HOLDOVER

Revised

ATCHISON ESTATES SUBDIVISION

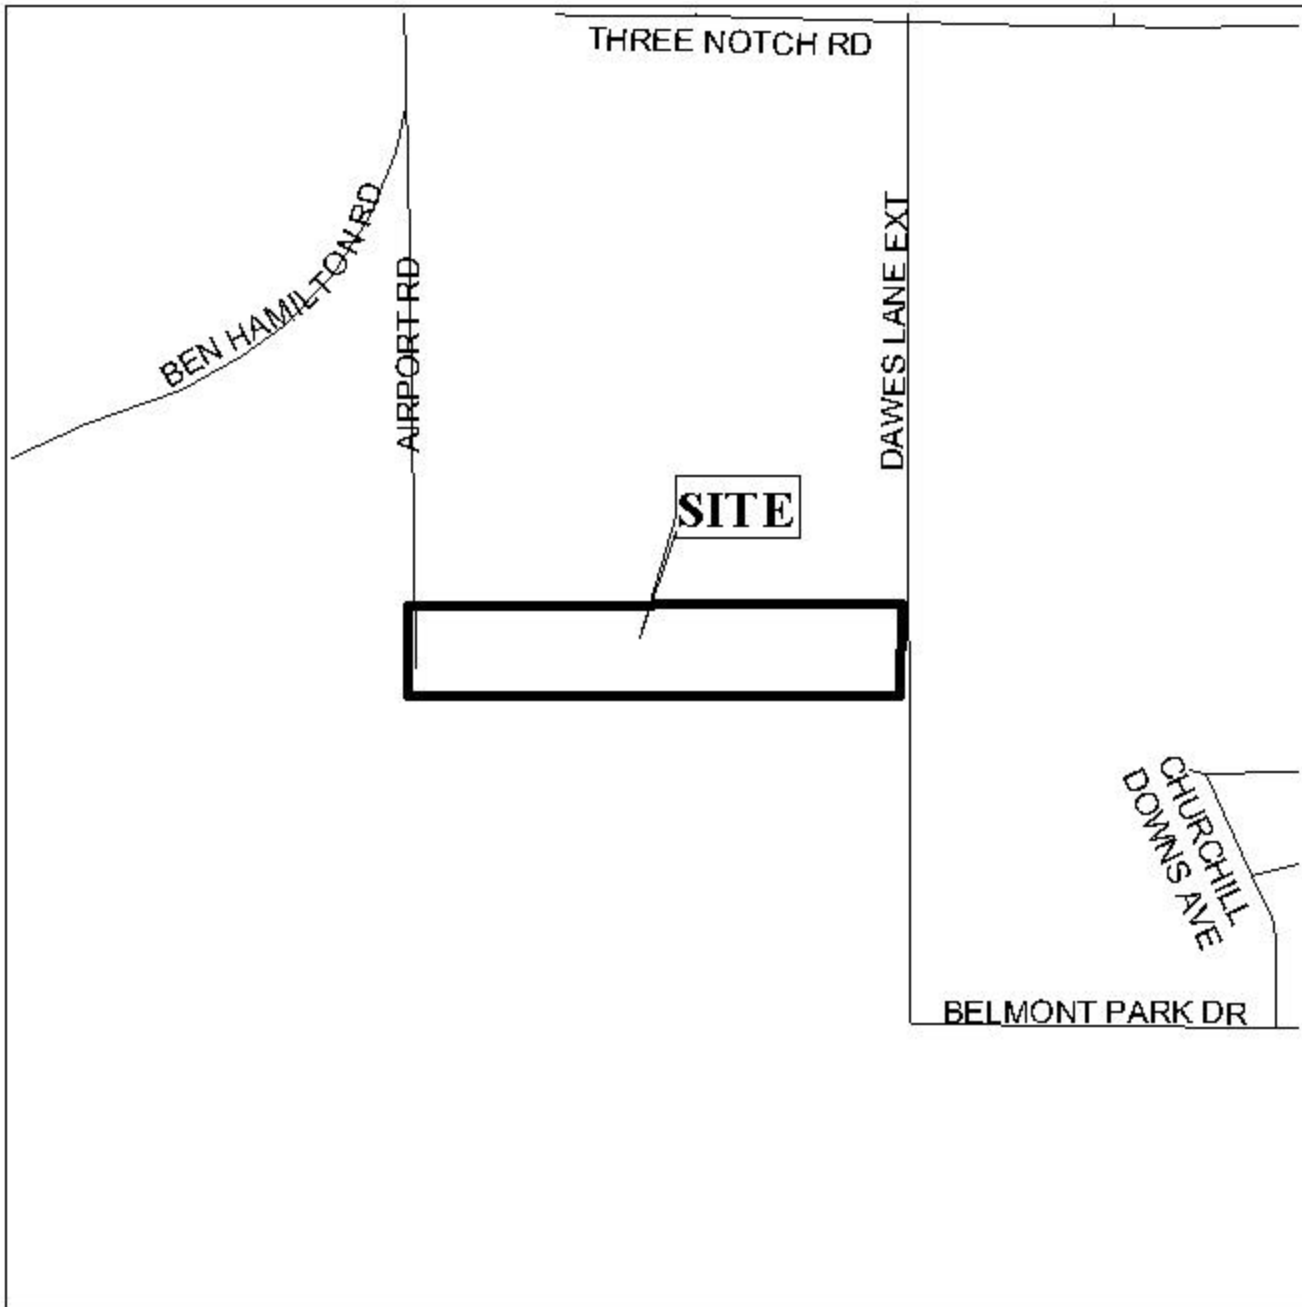
Airport Road, which has no existing right-of-way shown, is a major street on the Major Street Plan, and as such requires a 100-foot right-of-way; therefore, the provision of a 75-foot setback from the centerline to provide for the right-of-way of the planned major street (which includes the required 25-foot minimum building setback) should be required. Additionally, a note should be placed on the final plat stating that Lot 3 is denied direct access to Airport Road.

The lots are narrow, only 150' \pm in width, and as proposed, would exceed the width to depth ratio. The width of the lots varies from 150' to 174' and the depth is approximately 2,595 feet. The Subdivision Regulation states that the maximum depth of a lot should not exceed 3.5 times the width of the lot. While this Section (V.D.3.) is often waived by the Commission, the lots are typically along waterways, or the proposed lots would be characteristic of the surrounding development. In this situation, the depth of the three lots would be 17 times the width, thereby exceeding the minimum standard by more than five times. Additionally, none of the other parcels in the surrounding area are developed as such, making the proposed plat out of character with the area.

The site is accessed by Airport Road, which is a dirt road. The current application would create three additional lots on substandard (dirt) road, and it is the practice of the Planning Commission to deny applications that would increase the number of lots on a substandard roadway.

Based on the preceeding, this application is recommended for denial for the following reasons: 1) the width to depth ratio for the three lots far exceeds the minimum standard required by the Subdivision Regulations; 2) the proposed plat is out of character with the

surrounding development; and 3) the plat would increase the number of lots that access a substandard (dirt) road.

Revised for December 18th meeting: *The applicant has submitted a revised plat dividing two of the lots in half and creating a “flag shape” for the third lot. With this configuration, the lots will still exceed the width to depth ratio; however, the depth is half of what it was as originally submitted.*

The plat meets the minimum requirements of the Subdivision Regulations and is recommended for Tentative approval subject to the following conditions: 1) the provision of a 75-foot setback from the centerline of Airport Road to provide for the right-of-way of the planned major street (which includes the required 25-foot minimum setback); 2) the placement of a note on the final plat stating that Lot 3 is denied direct access to Airport Road; and 3) the placement of a note on the final plat stating that any lot which are developed commercially and adjoin residential property must provide a buffer, in compliance with Section V.D.7. of the Subdivision Regulations.
